**RE: Response Letter
NWD Trucking – 100 Duchaine Blvd.
New Bedford, Massachusetts**

We have enclosed a response letter, HydroCAD Reports, supporting documents and revised plans in response to the comment letter prepared by Nitsch Engineering dated March 20, 2017 in regards to their review of the Site Plans.

Nitsch Engineering Comments

SOIL PROFILES

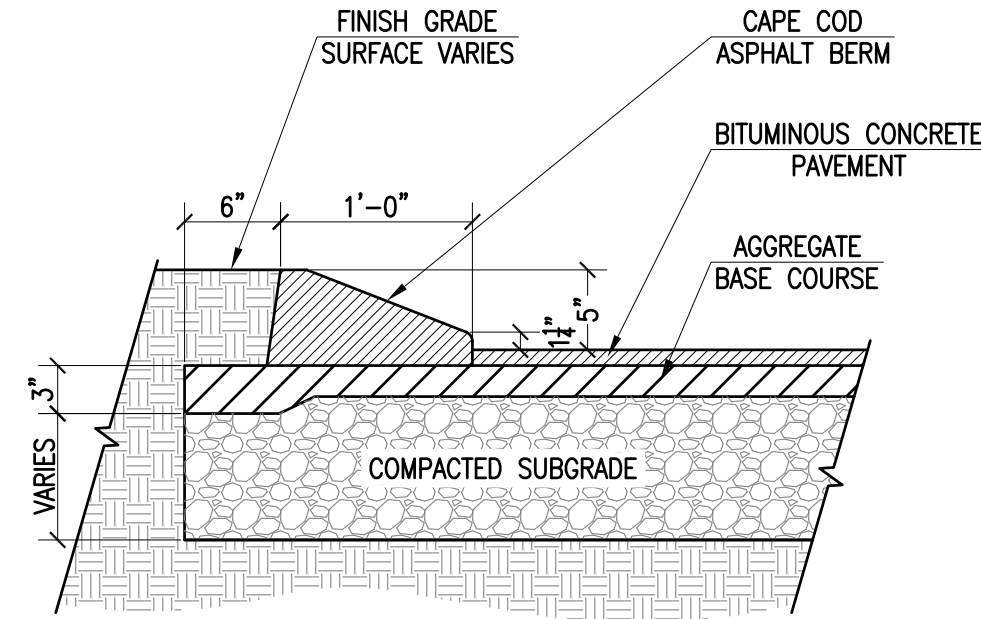
We recommend that the seasonal high groundwater elevation, once it is obtained, be added to the infiltration field detail.

The seasonal high groundwater elevations have been investigated and are reported within the Soil Logs on Detail Sheet 7.

16 SEDIMENT FOREBAY W/ GRAVEL FILTER
8 NOT TO SCALE

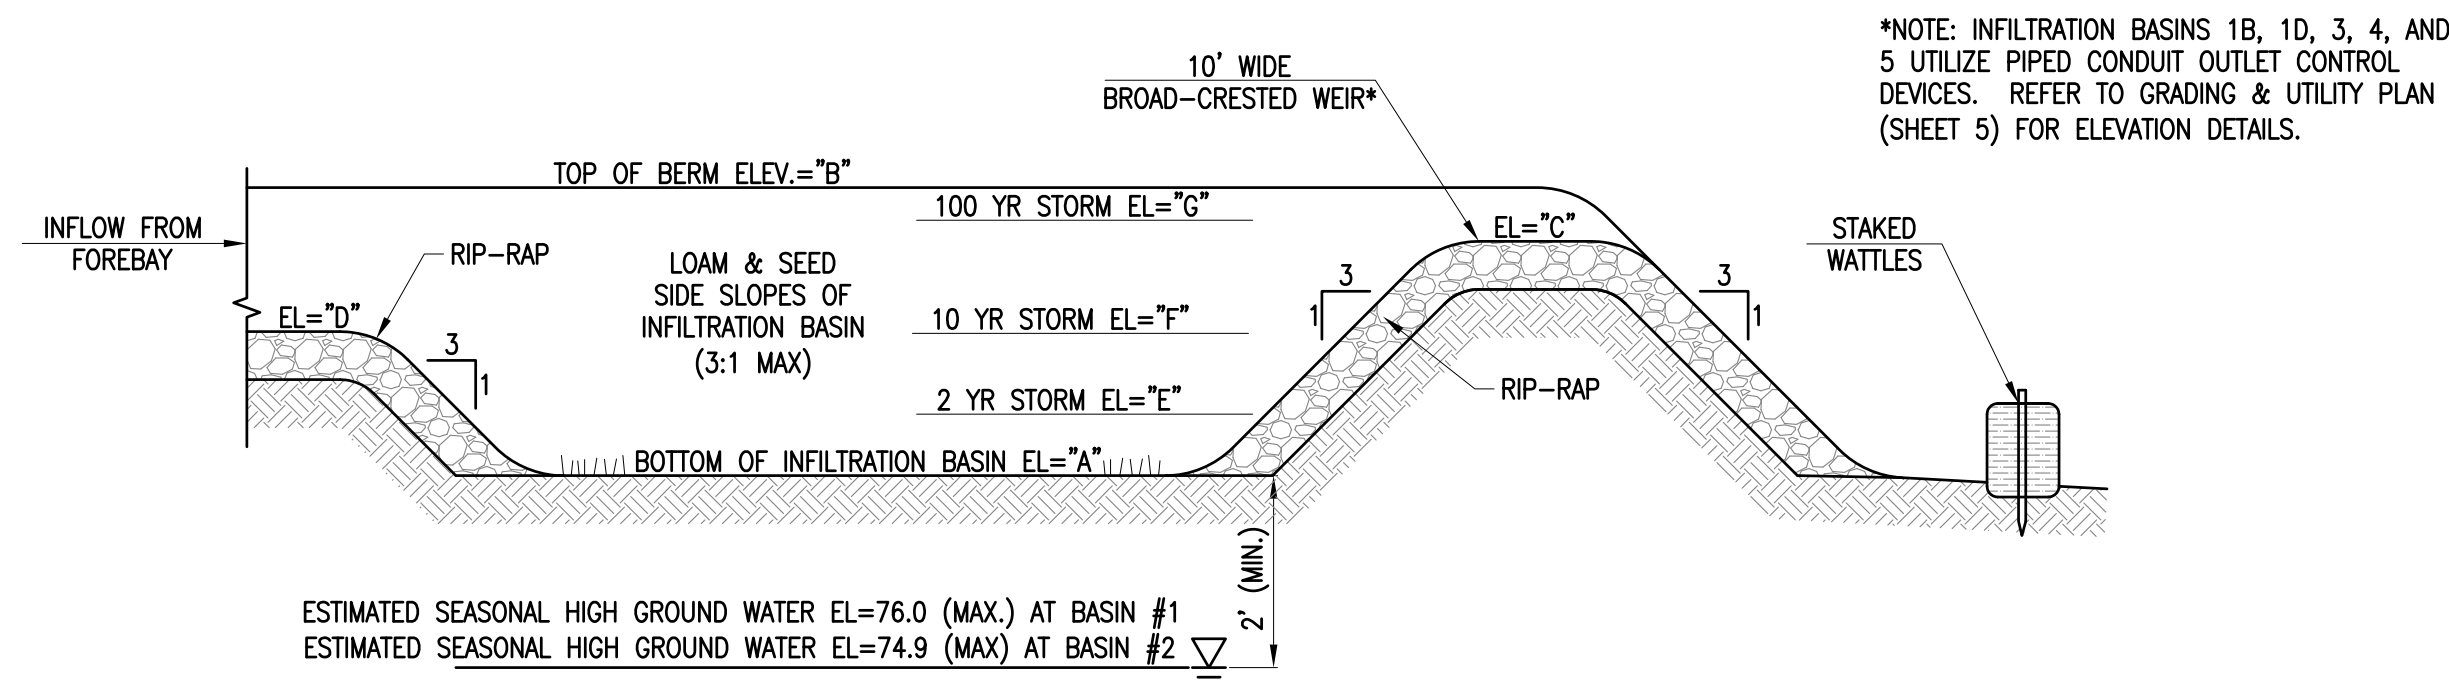
It appears that stormwater routed to the water quality basin located to the west of the parking lot is routed to the main area of the basin and not the sediment forebay. It does not appear that the sediment forebay collects any water. There is a filter strip between the parking area and the basin. The filter strip should be located between the parking area and the sediment forebay.

The sediment forebay at this basin has been revised to collect all runoff from the impervious areas prior to discharge to the basin.

18 DETENTION BASIN
8 NOT TO SCALE

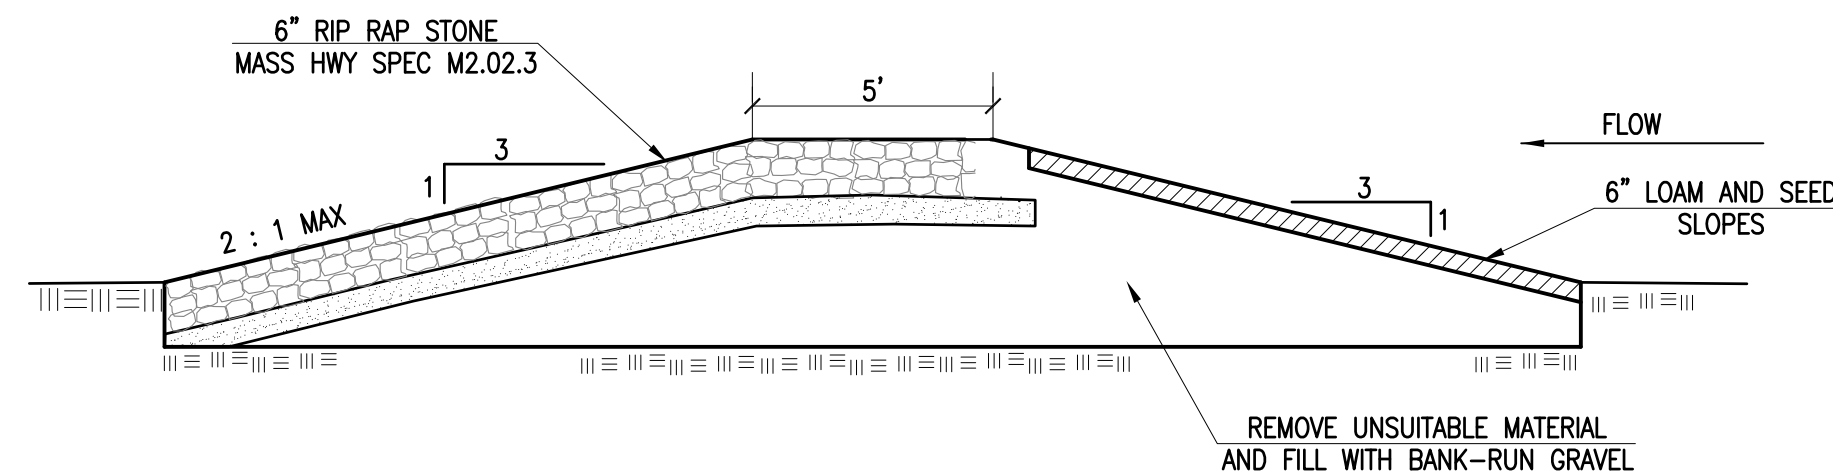
We cannot verify the storm elevations shown in the detention basin cross-section.

The detention basin detail shows seasonal high groundwater elevation at 95, which is incorrect.

Storm elevations on the Detail Sheet have been corrected to reflect the post-development conditions shown in the HydroCAD calcs.

The seasonal high groundwater elevation has been revised to reflect the correct conditions.
